SECOND/THIRD READINGS SUMMARY SHEET

CASE: C814-2023-0057 (200 E. Riverside PUD) DISTRICT: 9

ZONING CHANGE REVIEW SHEET

CASE: C814-2023-0057 (200 E. Riverside PUD) DISTRICT AREA: 9

Figure 2: Barton Springs Road Extension Cross Sections

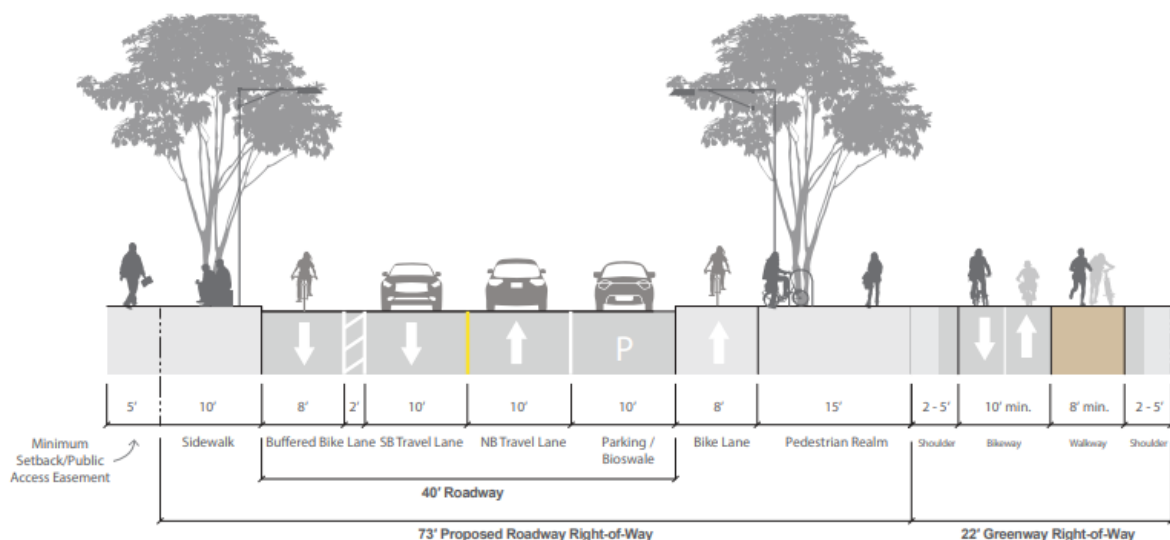
ATD 9. Additional Comments:

17. THE PUD WILL BE FOCUSING ON SIGNIFICANT IMPROVEMENTS FOR PEDESTRIAN AND BICYCLE ACTIVITY FROM EAST RIVERSIDE DRIVE TOWARD LADY BIRD LAKE IN COORDINATION OF PROJECT CONNECT AND AUSTIN TRANSIT PARTNERSHIP. THE IMPROVEMENTS WILL BE ON THE WEST SIDE OF THE PROPERTY WITH CONNECTIVITY TO THE PARKLAND DEDICATION AREA ON THE ADJACENT PROPERTY TO THE NORTH. THE IMPROVEMENTS WILL PROVIDE CLARITY IN BOTH WAYFINDING AND GREATER PEDESTRIAN AND BICYCLE TRAFFIC SAFETY WITH CLEARLY DELINEATED PATHWAYS.

TPW recommends that the PUD specify these improvements by offering deference to the South Central Waterfront Plan, specifically the 22' "greenway" and/or the desired cross-section as identified by Project Connect when available:

- U1: Comment pending TPW comment #6.
- U2: **Comment pending. Land Use Note #24-** at this time it is unclear how these “improvements” will be above and beyond the base line requirements of the TCM. Please clarify what these improvements may entail and add the language “subject to approval from Director” to the proposed note.

Figure 2. Improvement Extent

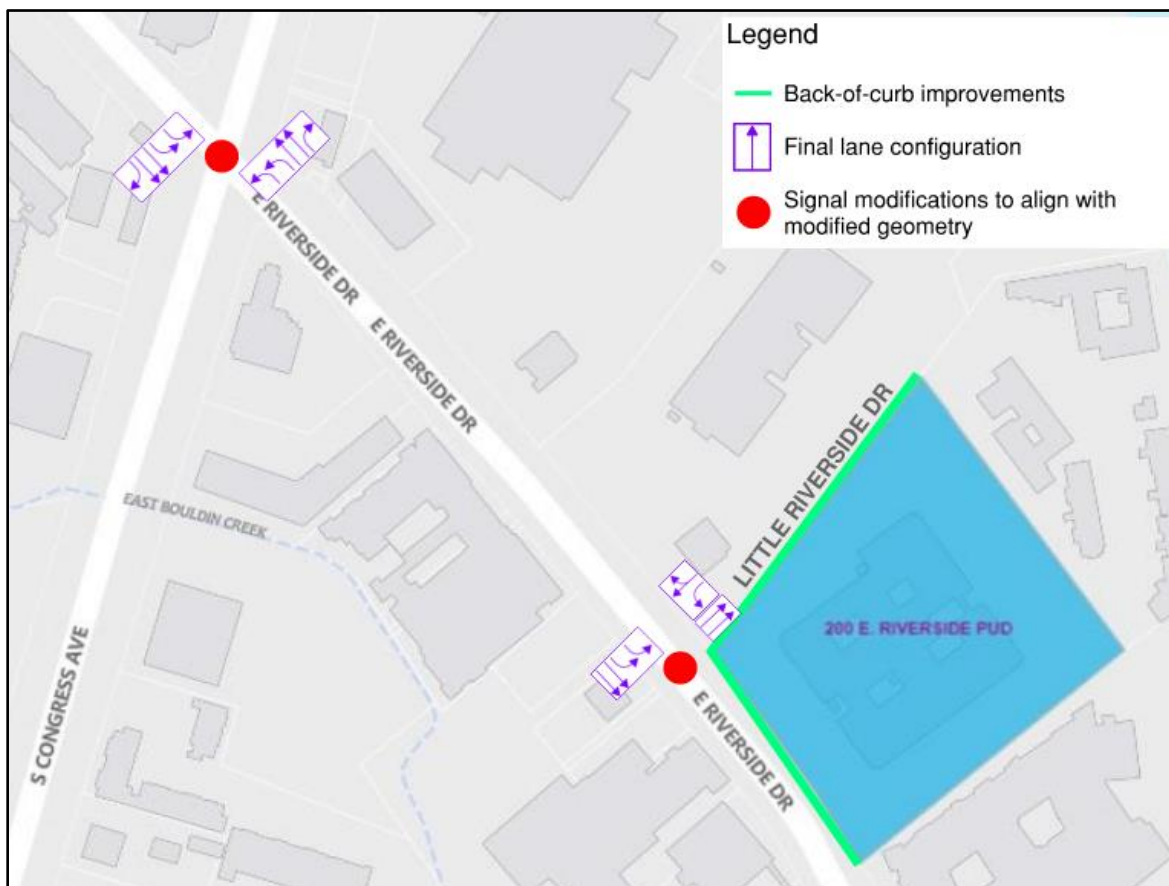
Install 1 RTL along WB E Riverside Dr approach
	Signal re-timing, lane assignment sign, signal head modification as needed to align with modified geometry
Back-of-curb Improvements (See Figure 2 for the improvement extent)	Design and construct back-of-curb improvements with the coordination of TPW along site frontages on Little Riverside Dr & E Riverside Dr
